Access Compliance Report Public Rights-of-Way (Curb Ramps)

Main Street: WEMBLEY_RD		Cross Street: SHAKESPEARE_DR		Location:	E
ADA ID: RPAT211201100954	Ramp Type:Type 1 - Perpendicular Diagonal Initial Pass/Fail: Fail		Overall Compliance: No	Severity Score:	16

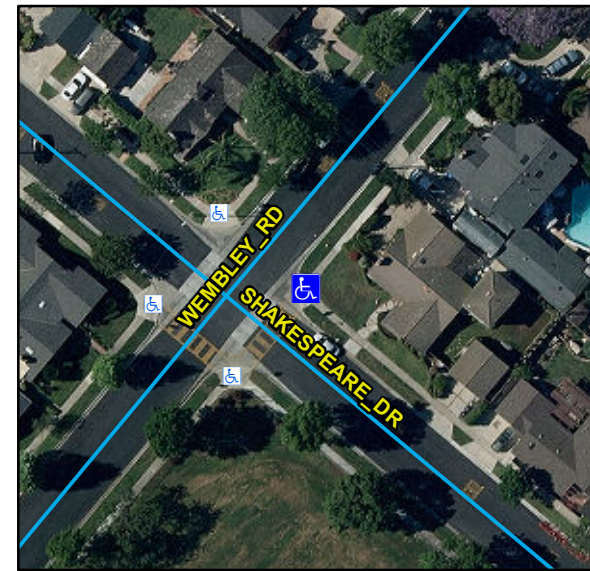
R304.2.2, R204.3, R304.5.3, STD 1115

Remove & Replace Curb Ramp With Two New Directional Ramps or Equivalent.
